RECALL BULLETIN: 121025FRV

PRODUCT(S) AFFECTED:
Encounter
Storm, Terra,
produced
11-19-2009
through
9-18-2012

SUBJECT:
Entry Step
Structural
Support

ISSUE DATE:
December
2012

Figure 1 - Step cage attachment area prior to repairs

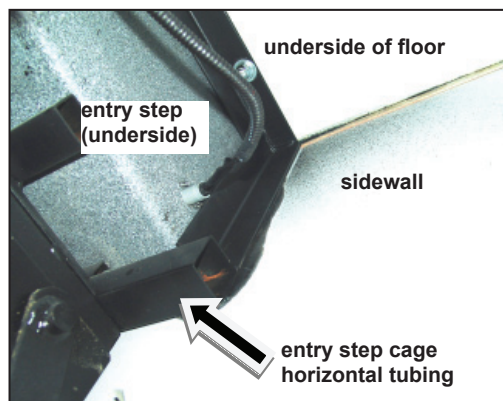
On motor homes affected by this recall, the entry step cage may separate from the sub-floor, possibly resulting in risk of personal injury, vehicle and/or other property damage.

1. Park the motor home on a paved, level surface. Place the transmission into Park and engage the parking brake.
2. Turn off the ignition and remove the ignition key. Maintain control of the keys until repairs are completed. Attach a notice, "DO NOT USE" to the ignition switch.
3. Chock the front wheels to prevent the motor home from moving in either direction while work is being performed.
4. Inspect the area under the motor home where the entry step cage attaches to the underside of the floor. If any damage is found, contact Fleetwood RV Dealer Technical Support to obtain Prior Authorization (PAR) and further instructions before proceeding.
5. Refer to Figures 1 and 2 to install new support brackets (included with the repair kit) to the horizontal tubing of the step cage, and into the back side of the sidewall. (Figure 1 shows the area before repairs are made.)

Figure 3

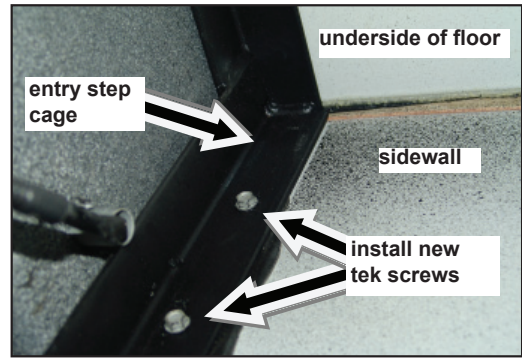
6. Referring to Figure 3, install two new tek screws through the vertical section of the step cage's angle steel and into the back side of the sidewall. Ensure screws do not pierce through to the front of the sidewall.
7. Open the entry door and remove the aluminum perimeter trim covering the floor at the left and right-hand sides of the step. See Figure 4.

Figure 4

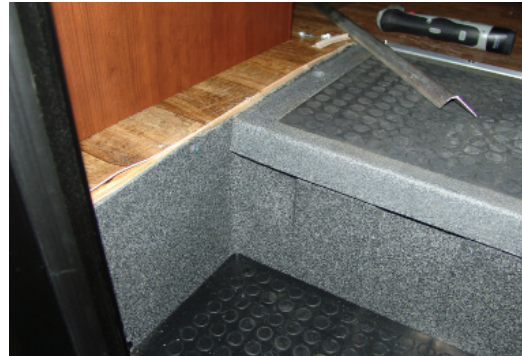
Note: A small length of cove molding may need to be removed where the floor meets the wall, to allow access to the plywood under the floor covering.

Figure 5

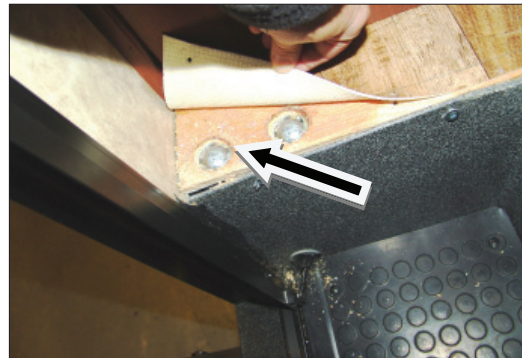
8. Pull up the corner of the floor covering. Measure and mark the location for a hole to be drilled through the floor near the step well, to allow the installation of a new carriage bolt. The hole's center should be 1" from the edge of the step well, and 1" from the sidewall. Countersink the hole so that the carriage bolt will be recessed into the floor after installation. See Figure 5.
9. Ensure the new bolt passes through the structural tubing in the floor and through the step cage's angle steel under the floor, as shown in Figures 6 and 7. Install the bolt using a torque washer under the head. Use a flat washer and lock nut to secure the bolt against the angle steel on the underside of the floor as shown in Figure 7. Use care to avoid crushing the structural tubing when tightening the carriage bolt.

Drill and countersink a hole for a new carriage bolt
